Historic Preservation Commission

MEETING NOTICE

To: Historic Preservation Commission Members
From: Adam Lindenlaub, Community Development Planner
Subject: COA Request at 525 Valor Way SW
Date: May 27, 2021

To: Historic Preservation Commission Members
From: Jeff Wozencraft, Community Development Planner
Subject: COA Request at 1829 Ridgewood Terrace SE
Date: May 27th, 2021

Northview Aspen 36"W x 36"H Vinyl Sliding Window with Built-in J-Channel

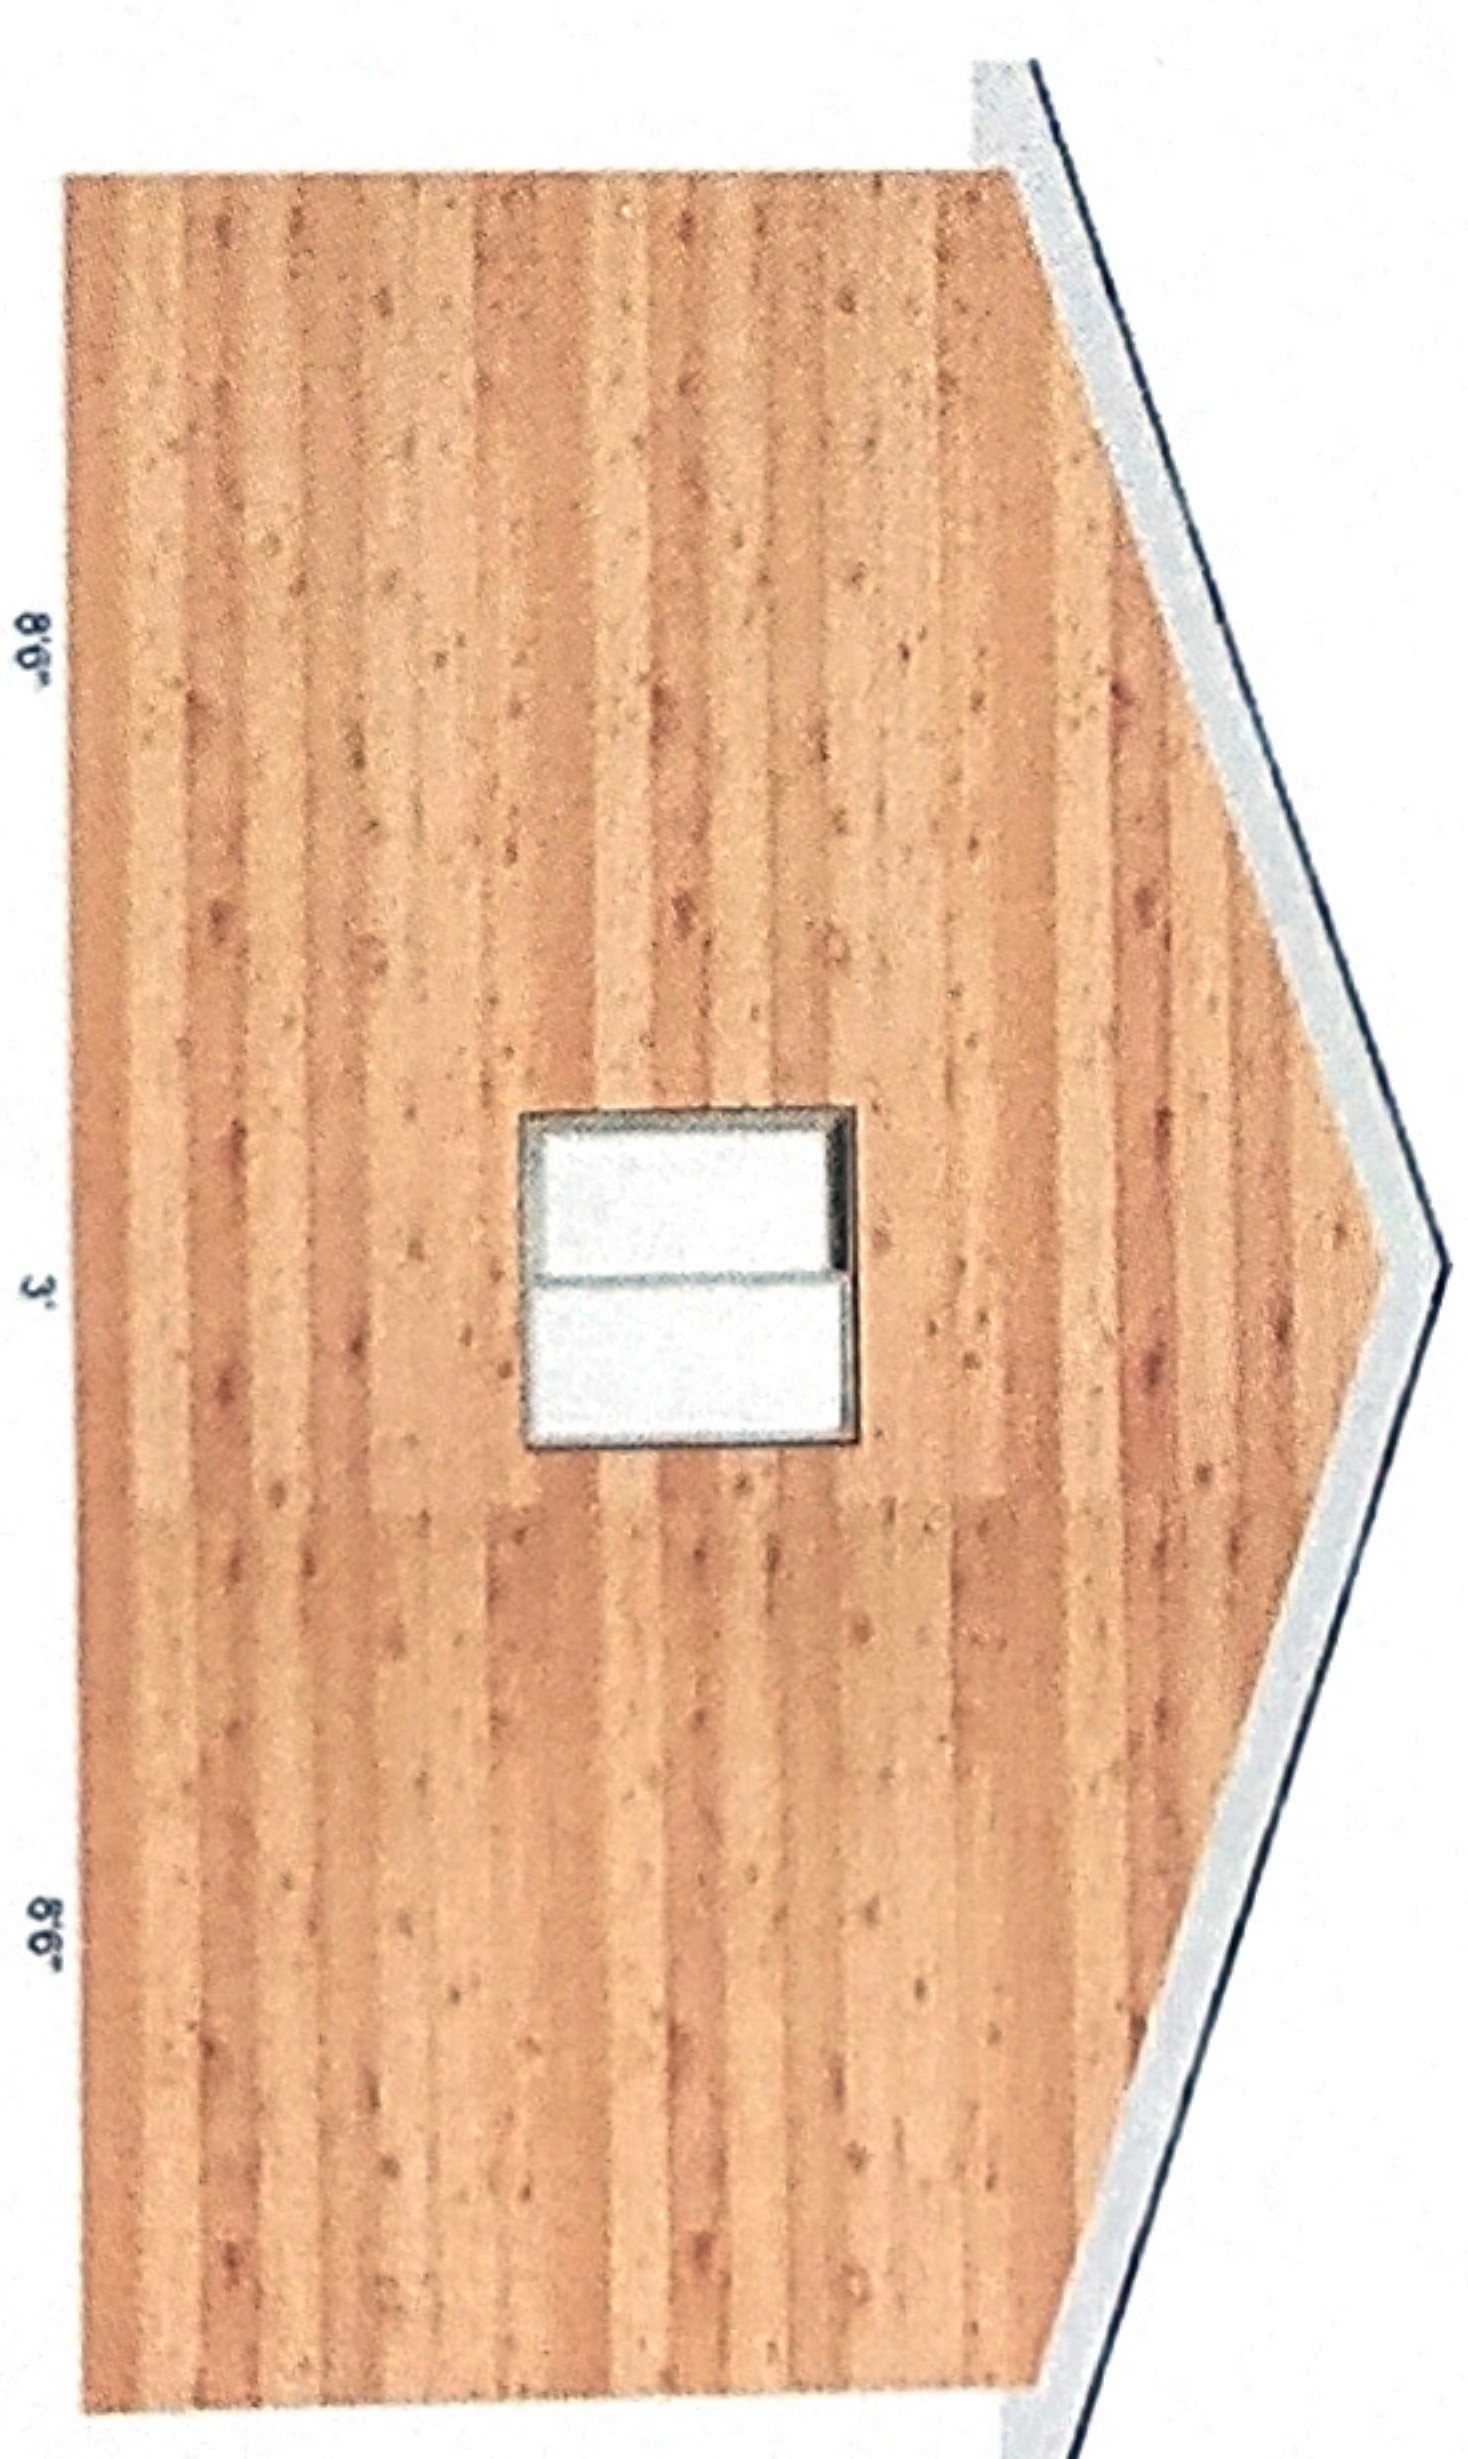
The applicant would like to rebuild a garage in the same spot as the one destroyed in Derecho. It will be on the south side of the property close to the alley. It will be constructed like the original with wood siding and roofing material to match the house. There will be three windows and one door as was in the original building. There will be a metal garage door facing the alley (south side). The windows will be vinyl and the door metal. The rest of the construction will be wood. There will be electricity run to the garage (like the original).

Staff Recommendation: Staff recommends approving the Certificate of Appropriateness for the new accessory structure because the materials propose will match the materials of the previous structure and the structure will be located in such a way that it is not visually prominent.

The image below shows the three buildings identified as North, East, and West on the demolition applications.

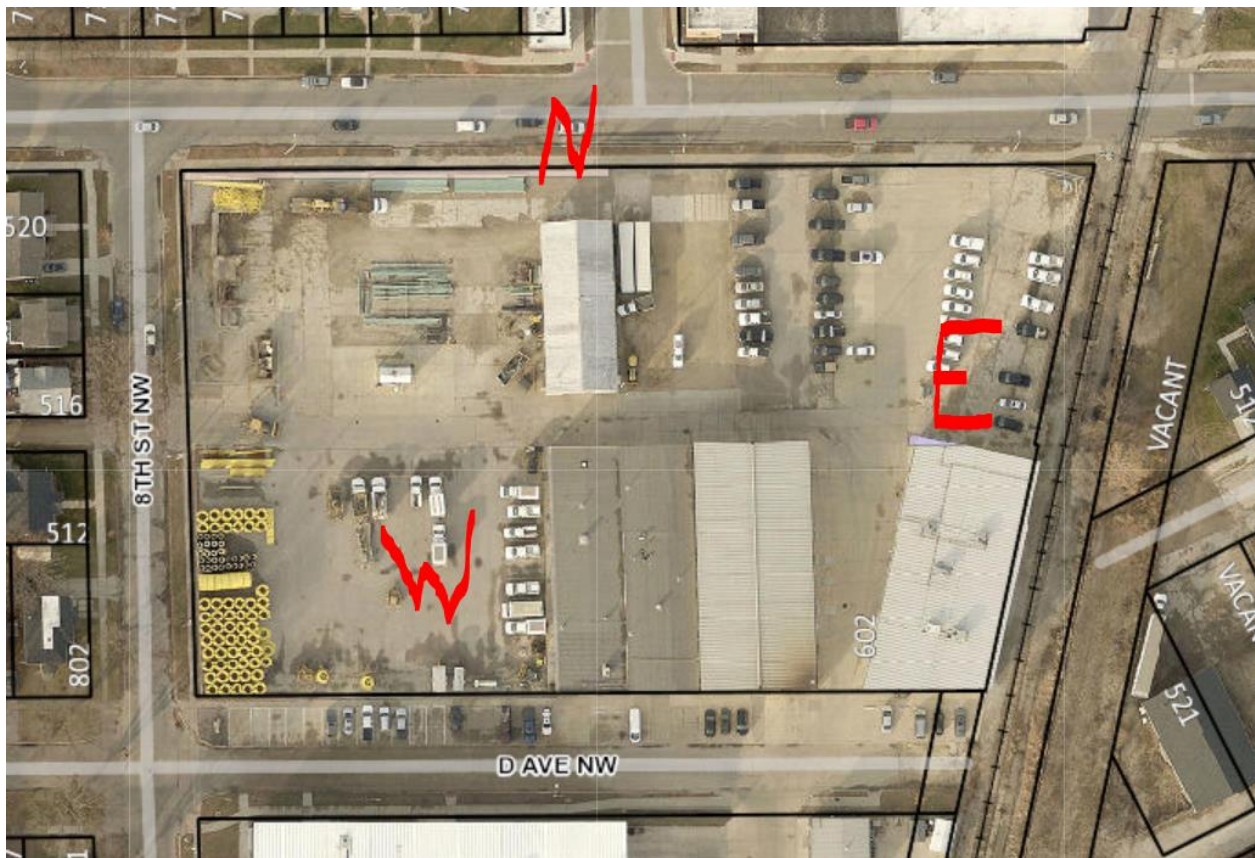
Background and Previous HPC Action: These three buildings, previously owned by Midamerican Energy, will be removed as part of the new connection of Ellis Boulevard NW to 6th Street NW as identified in the approved Framework Plan for Reinvestment and Revitalization (2008) and the Northwest Neighbors Neighborhood Action Plan (2017).

The exact age of the buildings could not be determined but they first appear in the 1913 Sanborn Fire Insurance Maps as part of the Cedar Rapids Sash & Door Company. The 2009 Architectural Reconnaissance Survey for St. Patrick's Neighborhood determined the buildings to be non-contributing to a district and individually not eligible for the National Register of Historic Places.

Rationale: There is no evidence of historic significance and the property is a poor candidate for local landmarking.

Recommendation: Immediate release
